ADDENDUM NO. 1 ELEMENTARY ADDITION TO SUMTER CENTRAL HIGH SCHOOL

Architect Job No. 24-38 July 24, 2024 DCM # 20240619

PROJECT:	PROJECT NO.	REFERENCE:
ELEMENTARY ADDITION TO SUMTER CENTRAL HIGH SCHOOL	24-38	ADDENDUM NO. 1
ARCHITECTURAL ADDENDUM DRAWING	DATE:	SHEET NO.
ANCHITECTORAL ADDENDOW DRAWING	7/10/2024	ADD 1

SHEET TITLE: GYM FLOOR PLAN & ELEVATIONS

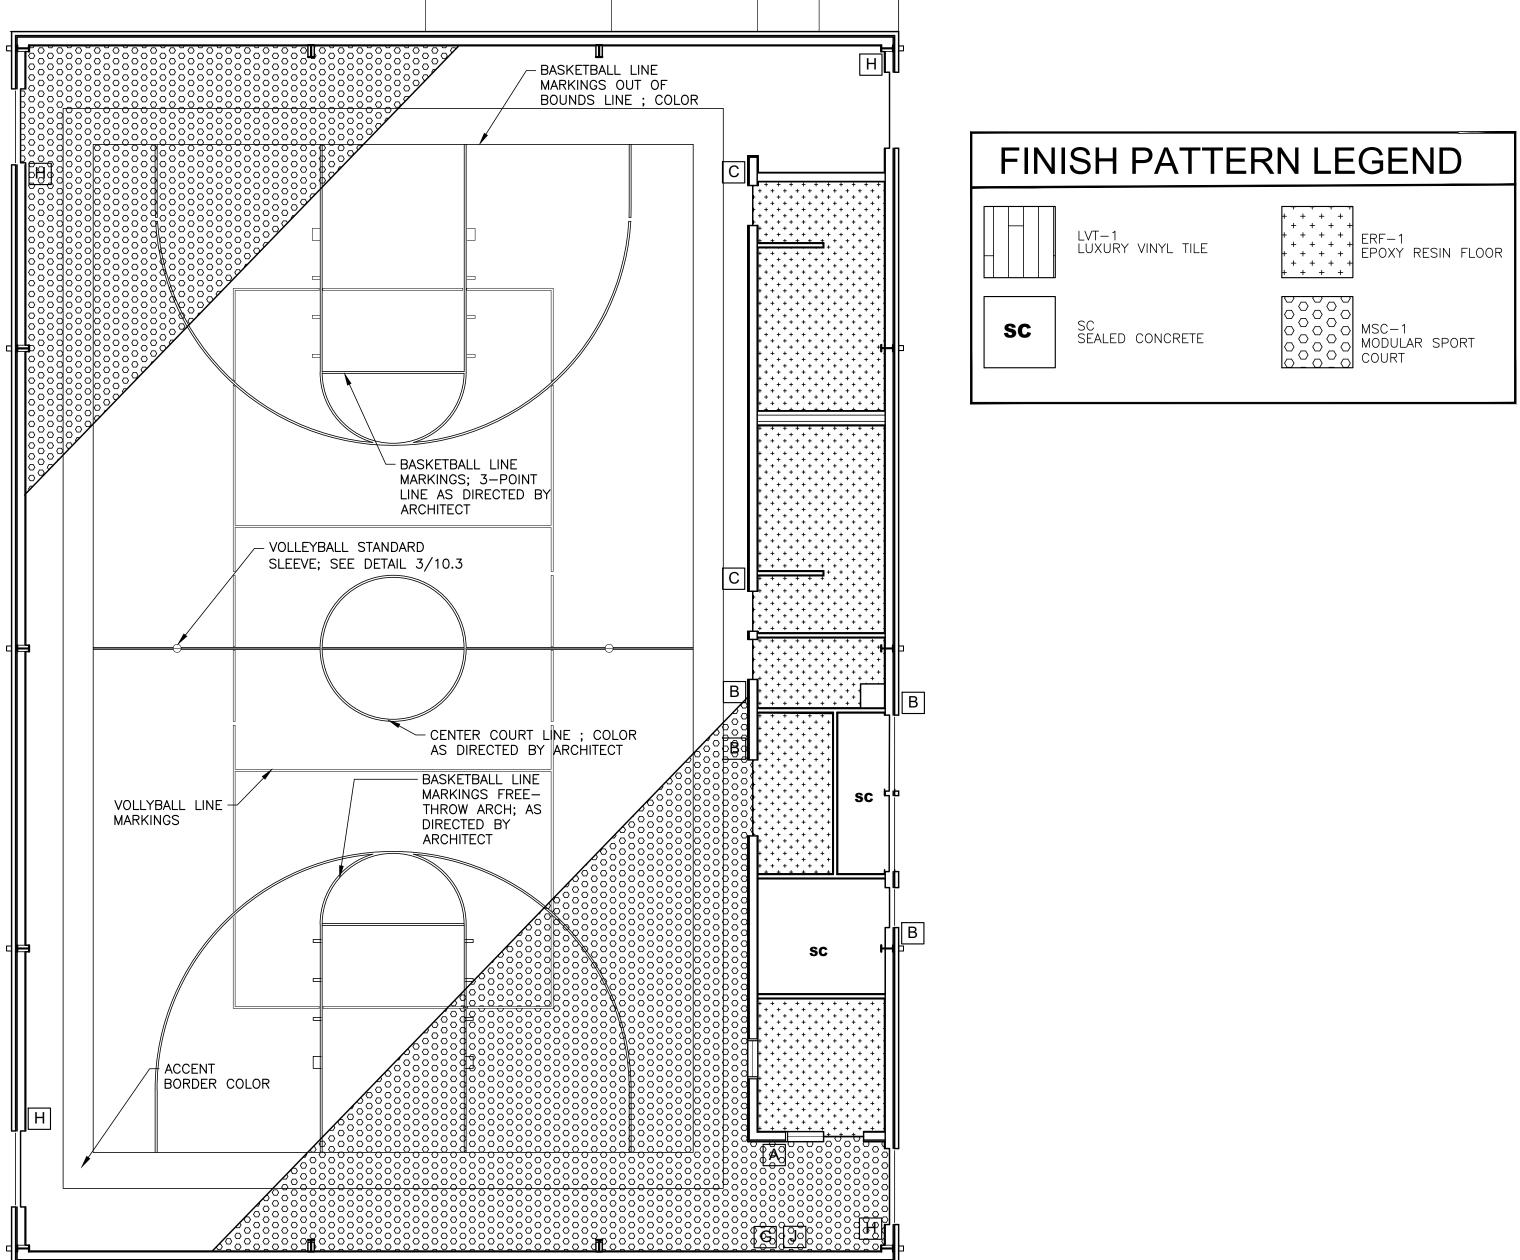
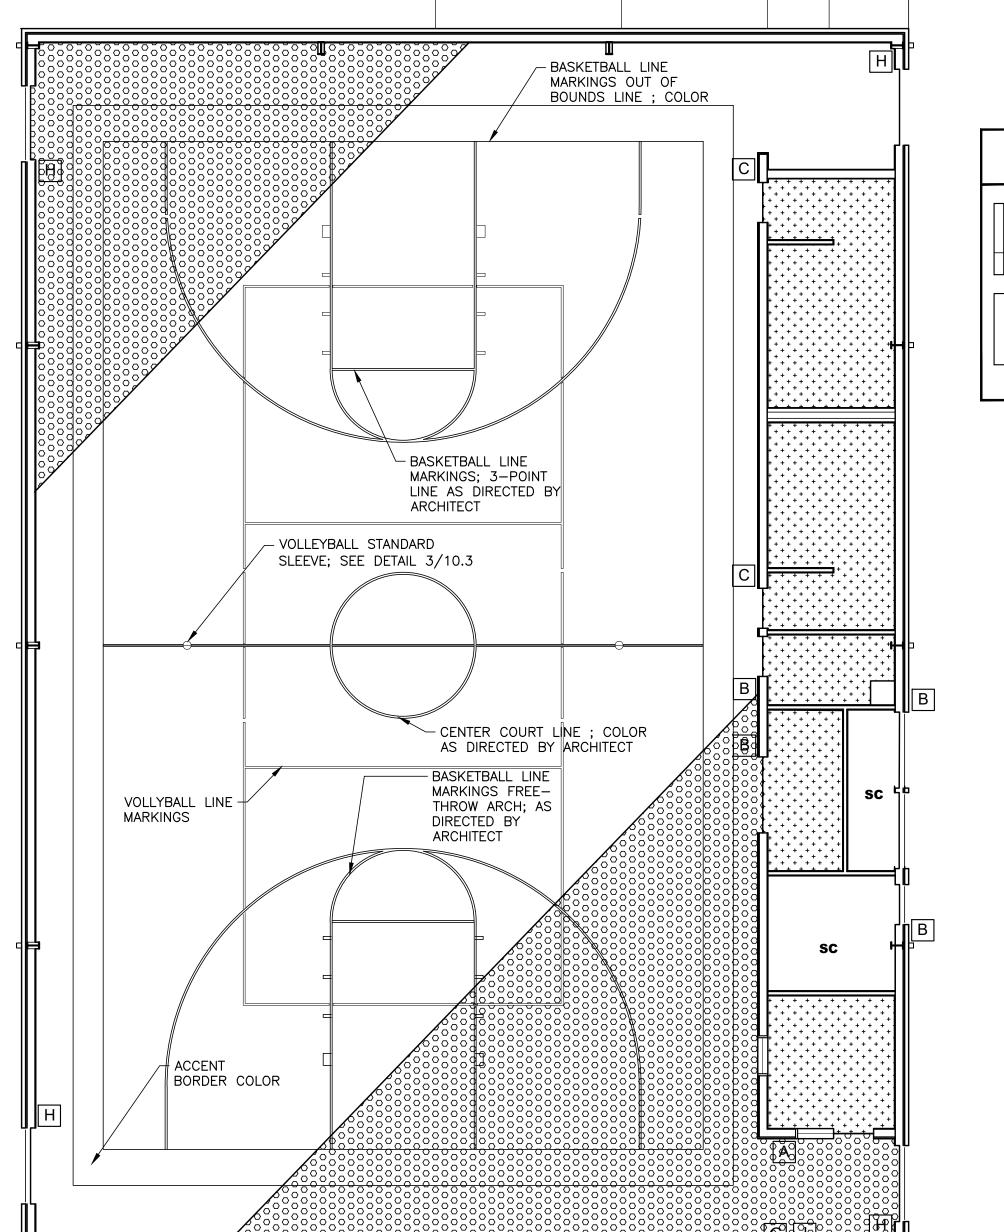
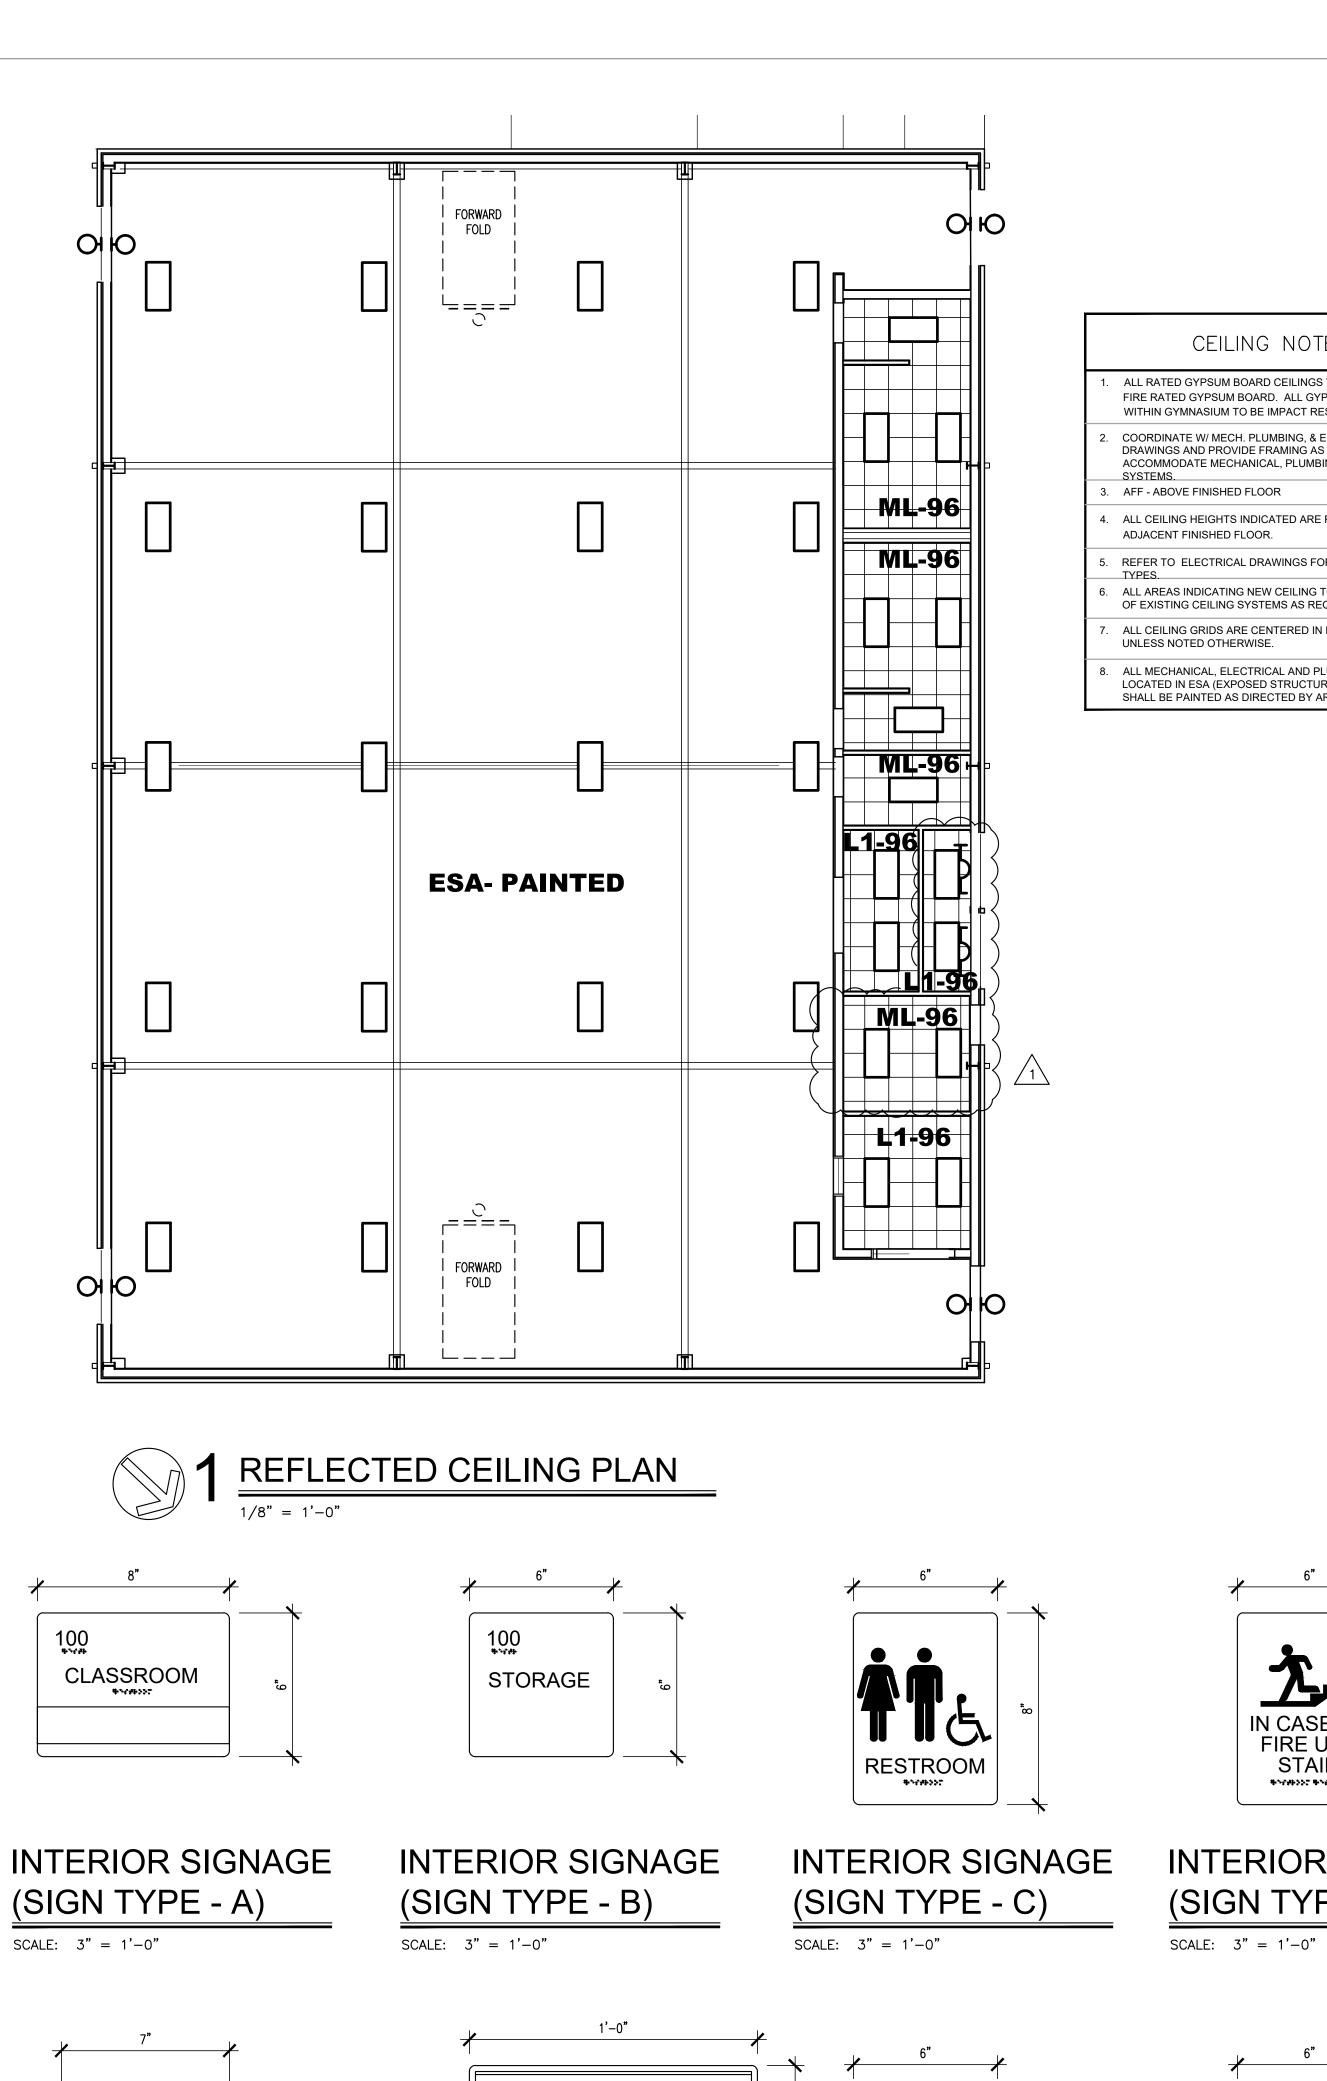
- 1. Add the attached architectural addendum drawing **ADD 1** in its entirety.
- See attached revised Sheet A2.2 to call out location for NEW CANOPY.
- See attached revised Sheet A10.1 added "LIGHT GAUGE STEEL TO 10'-9" A.F.F".
- 4. See attached **A10.3** for revisions to the Reflected Ceiling Plan.
- 5. See Sheet <u>S3.1</u> Sections and Details: Steel veneer lintel with anchorage revised to have plate extension to better coordinate with architectural drawings as well as "Contractor Option" added.

ЈОВ NO. **24-38** SHEET NO: M1.1

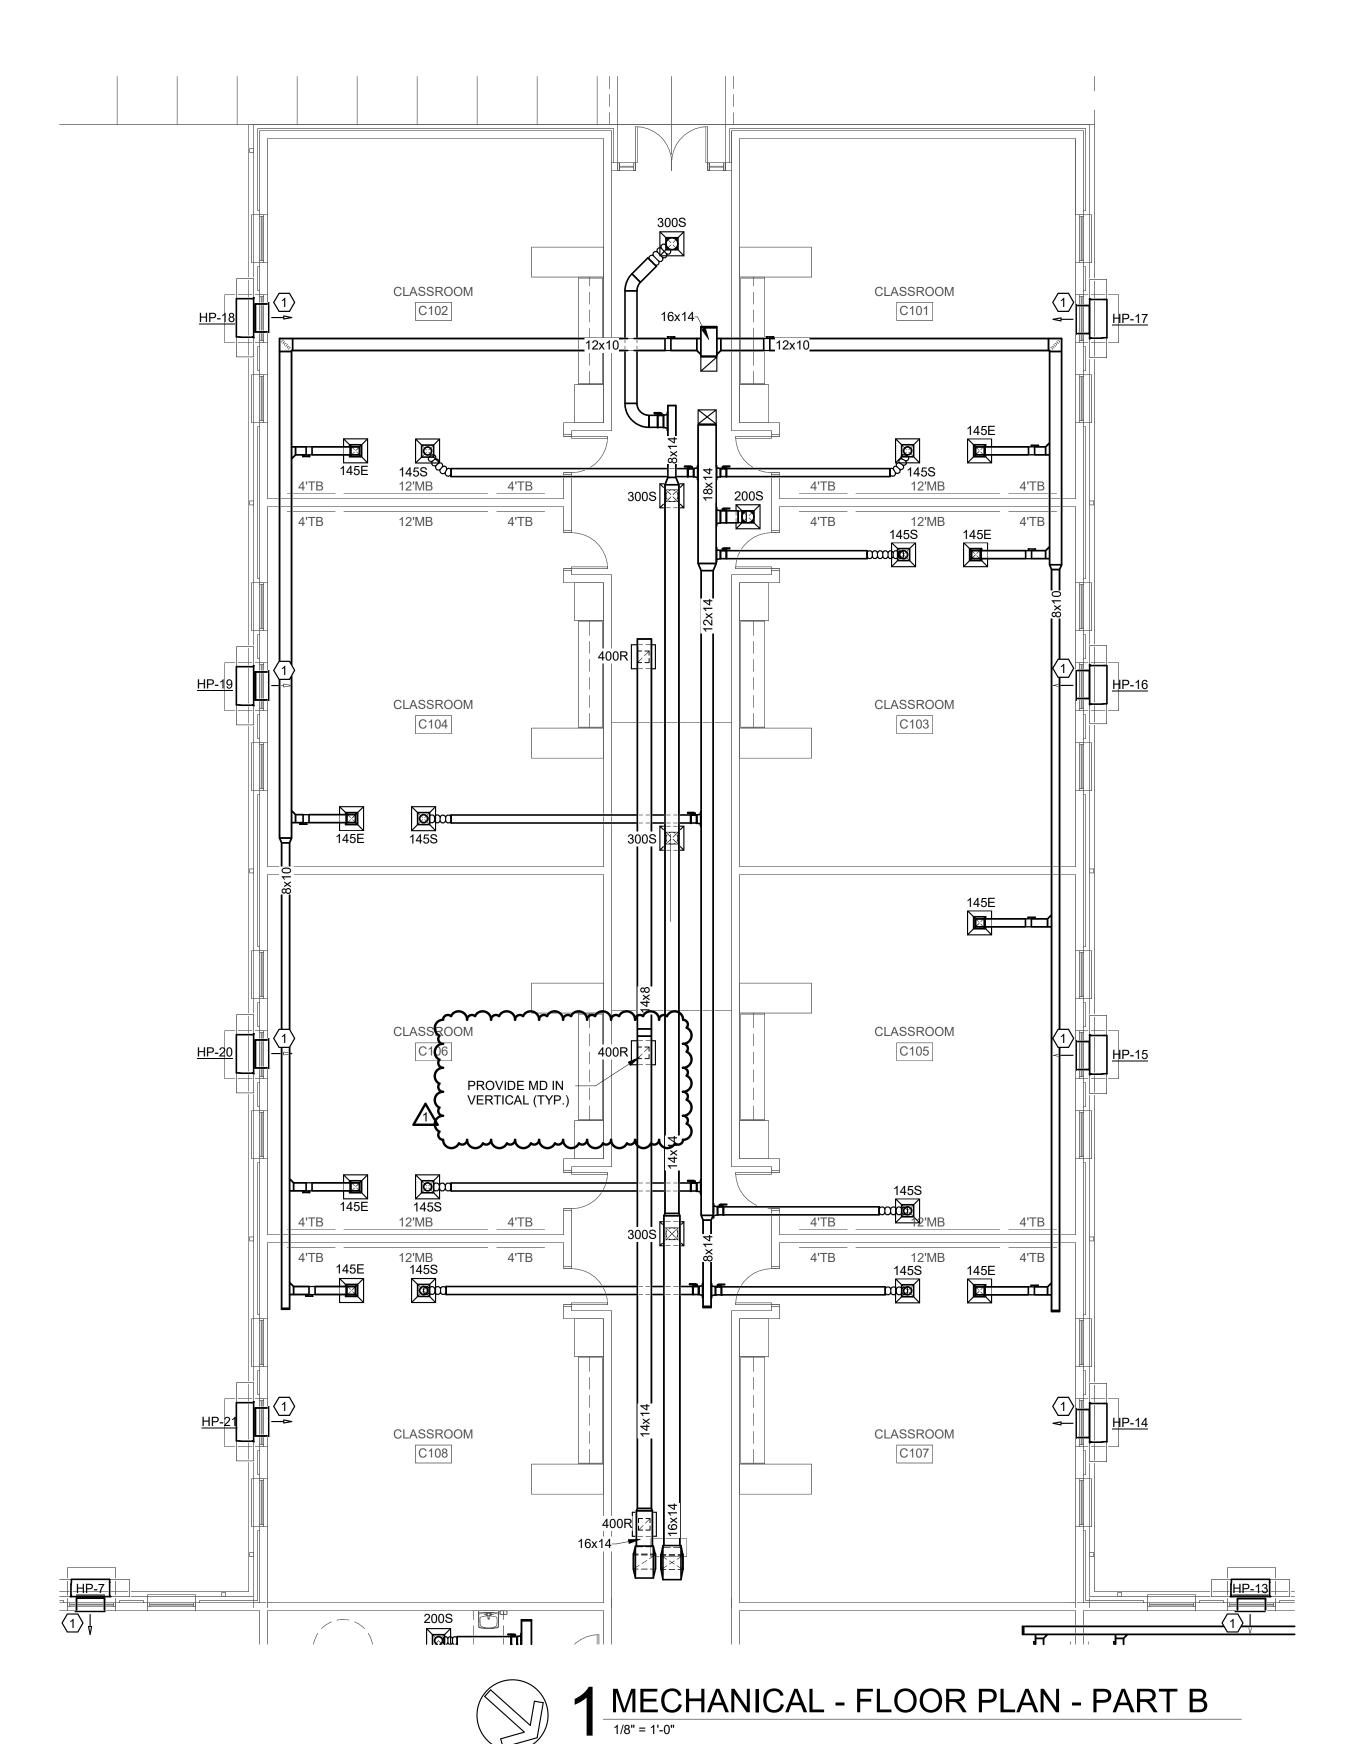
- WALL HUNG UNIT WITH STACKED SIDEWALL SUPPLY AND RETURN GRILLES. COORDINATE MOUNTING HEIGHT WITH ARCHITECT.
- CONTRACTOR TOO COORDINATE THE INSTALLATION OF UNIT ON GRADE AND PAD WITH ARCHITECTURAL EXTERIOR FINISHES. DUCTWORK TO RUN UP EXTERIOR AND PENETRATE WALL WHERE ARCHITECT CALLS OUT FOR SPECIFIED GAP IN FINISHES. COORDINATE WITH ARCH AND GC.
- 10. See attached Sheet **M1.2** revised to add the following:

MECHANICAL - ROOF PLAN PART B

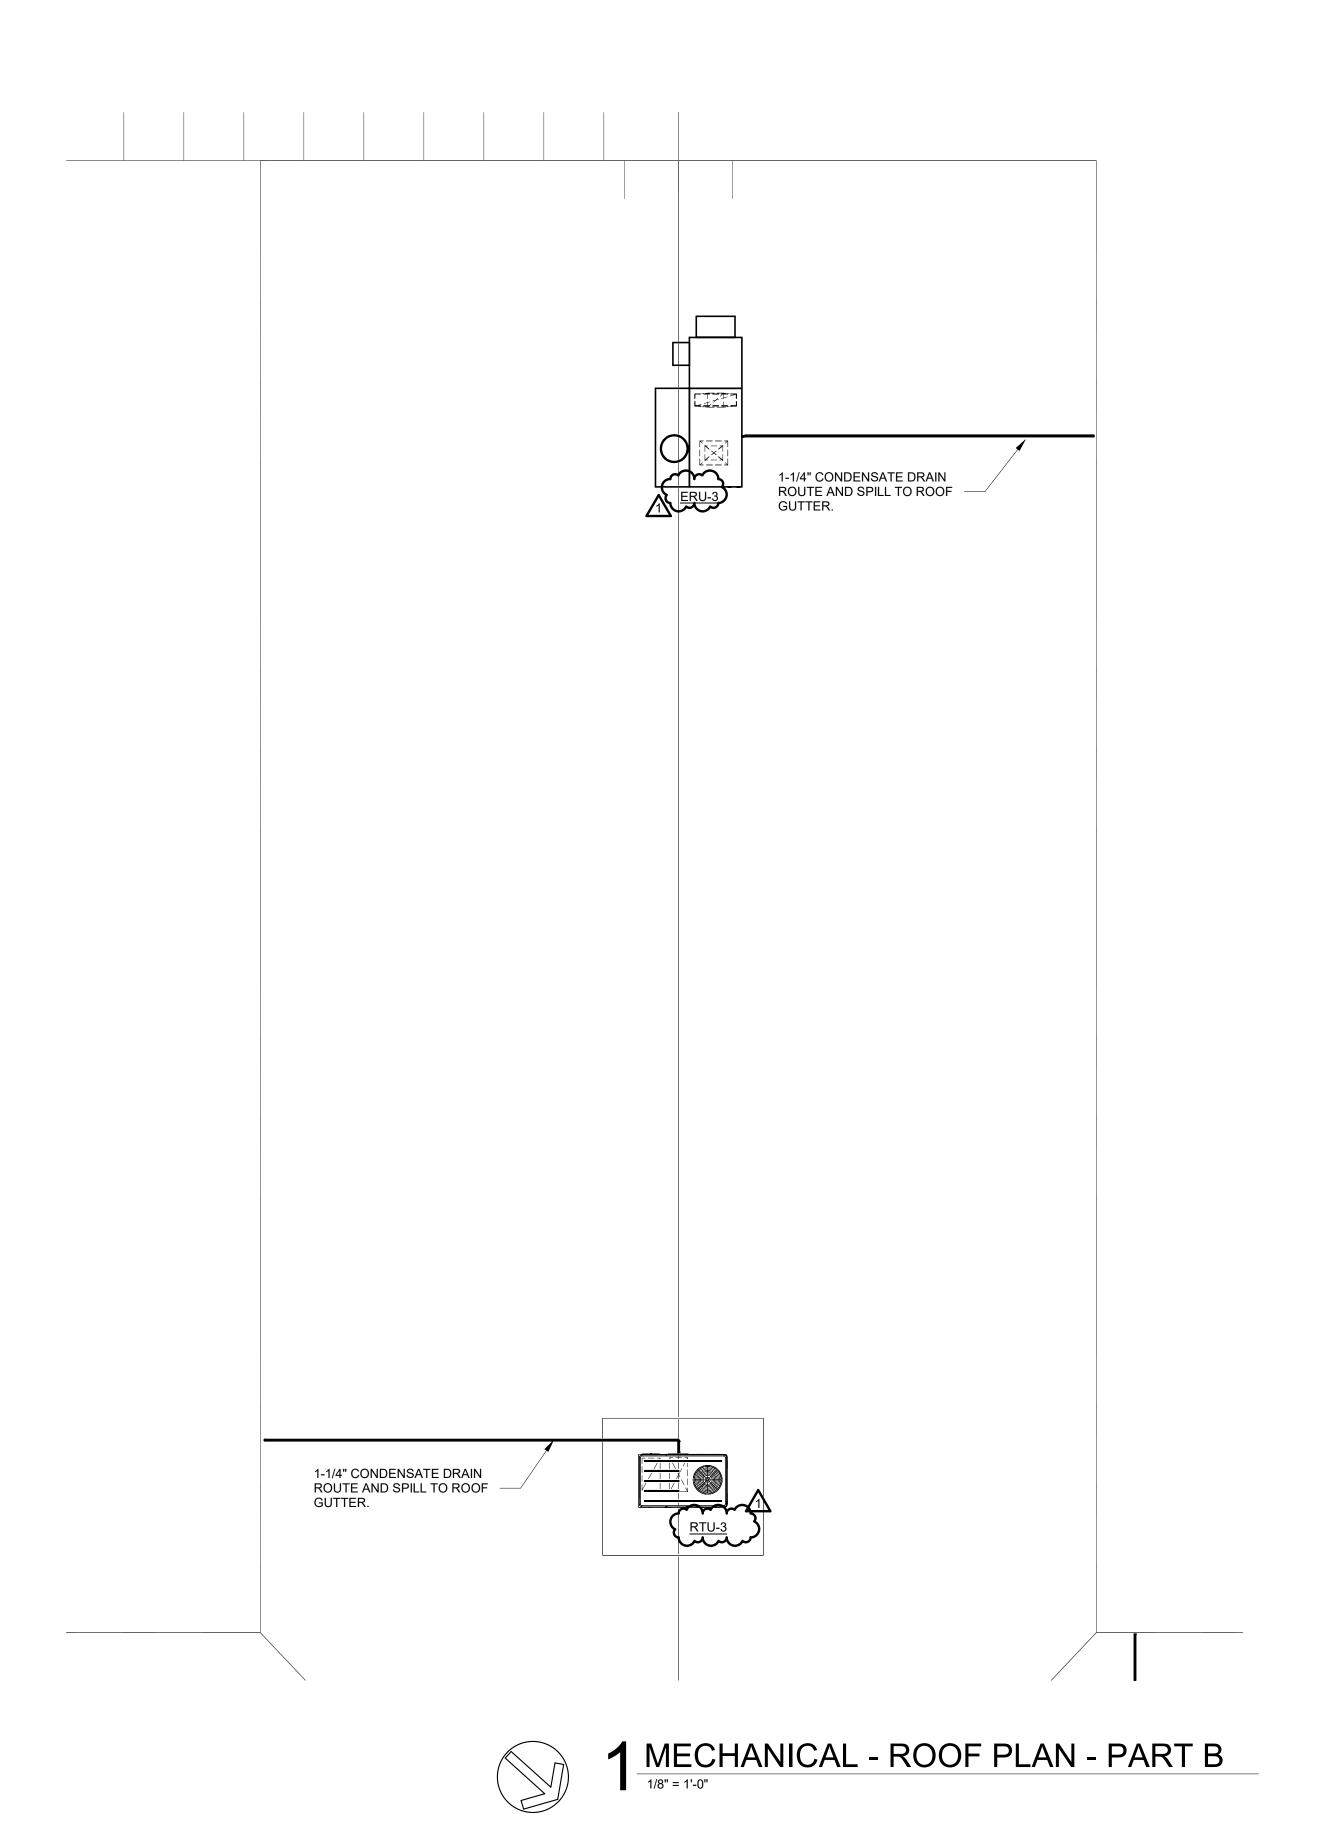
- 12. See attached Sheet **M2.1** revised Mechanical Roof Plan B.
- 13. See attached Sheet **M2.2** revised Mechanical Roof Plan C.
- 14. See attached Sheet **M3.0** revised Mechanical Piping Floor Plan Part A.
